HISTORIC PRESERVATION COMMISSION REPORT

Case Name: **Merican Residence Merican Carport Conversion**

Case Number: **3-HP-2016**

Request: Request approval of a Certificate of Appropriateness - Historic Preservation and Historic Residential Exterior Rehabilitation funding for the enclosure of an existing 2-car carport into a garage.

ATTACHMENT #7

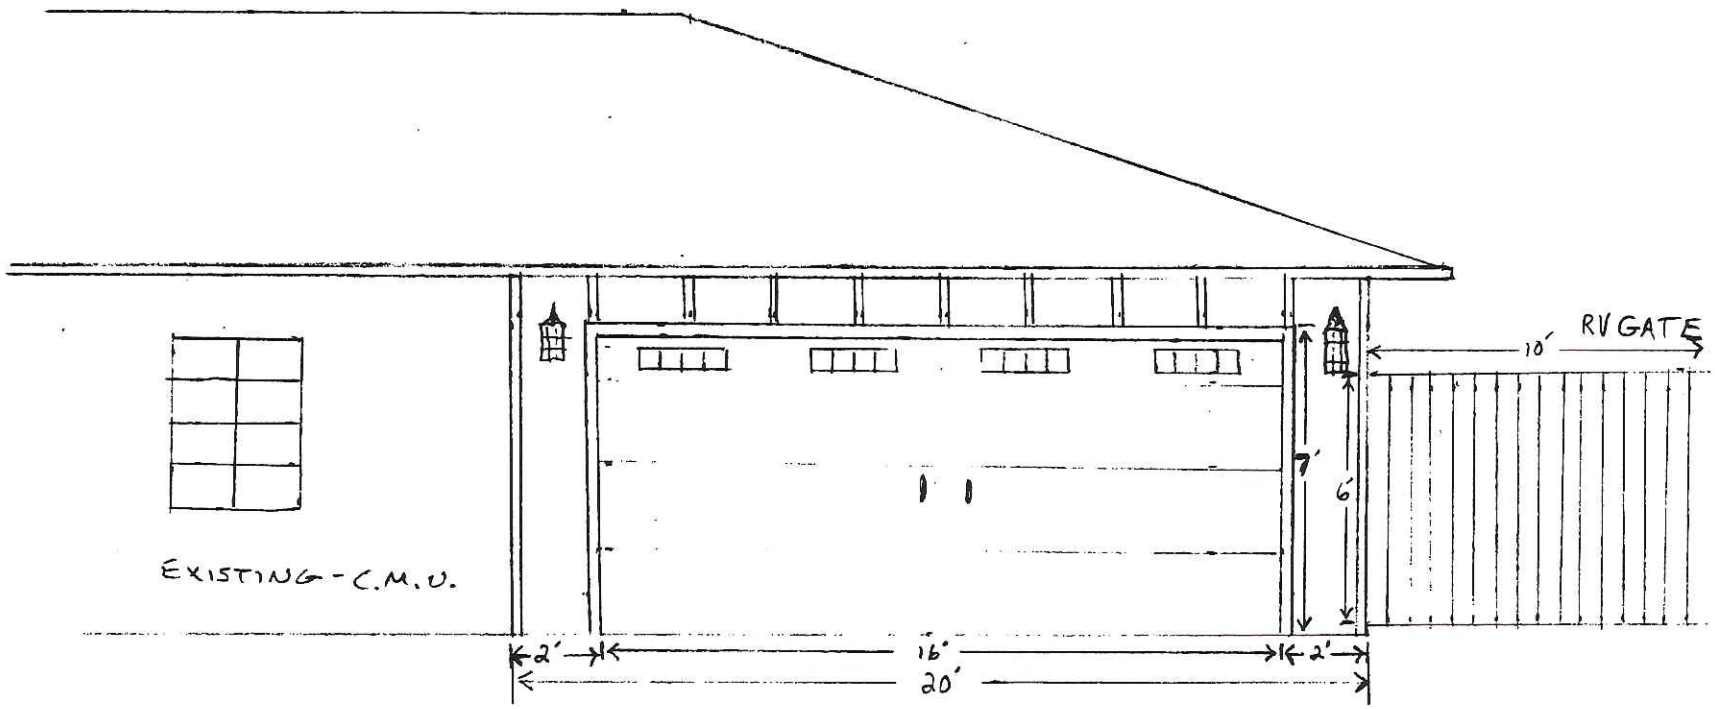
The proposed conversion of the carport to a garage enclosure does maintain the structure's original, simple, geometric shape, proportion, and massing. The enclosure of the carport will provide more of the "California Ranch" style home. The garage door will include a multi-panel façade with rectangular windows, and will preserve the simple ranch style of Village Grove guidelines. A common modification to the homes within this community is the enclosure of the carports. Of the thirteen (13) single-family units on this subject street, four (4) have an existing enclosed two-car garage. Of those four properties, one property has windows incorporated in the garage door façade.

The proposed carport to garage enclosure includes the garage door with a flat board and batten system, with 1"x2" wood strips, that is consistent with character of historic exterior wall materials found on the original building.

2. Proposed garage door must not contain any windows and contain the traditional grid pattern. Final garage door design shall be approved with final plans submittal.
3. New garage enclosure facades shall be painted and constructed to match exiting residence in color and materials; and the enclosure facades will include flat board and batten system, with 1"x2" wood strip.
4. New side-entry door must be consistent with door elevation designs as shown on Historic Preservation Guidelines for Village Grove 1-6 Historic District, Page 31. All window panes must contain either grid or diamond grid design. Final door design shall be approved with final plans submittal.

ATTACHMENT #8

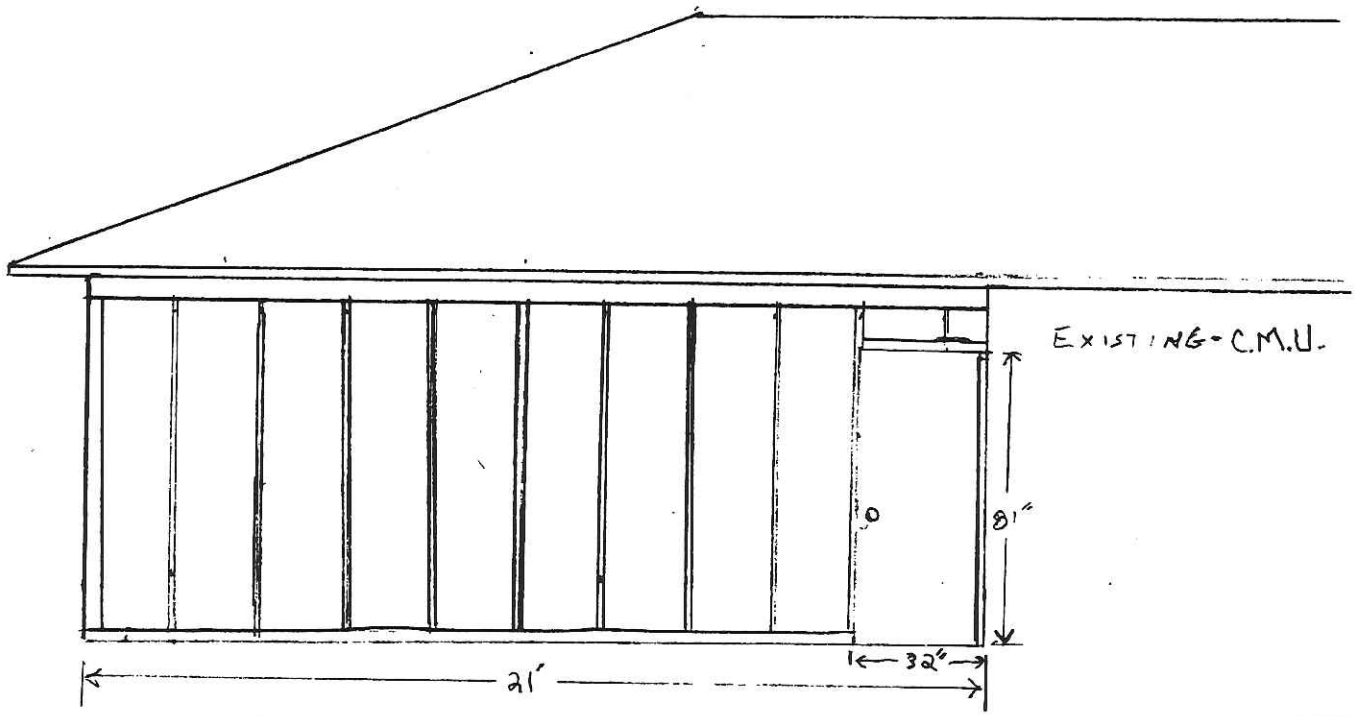
The carport enclosure will be painted to match the existing, sage green color. The exterior of the building does not appear to have had sandblasting or chemical removal of the previous paint. The painting and construction of the enclosure will include the flat board and batten system, with 1"x2" wood strips, that is consistent with character of historic exterior wall materials found on the original building and surrounding homes. The enclosure will provide a door, on the western elevation, that is consistent with garage door location in the district.
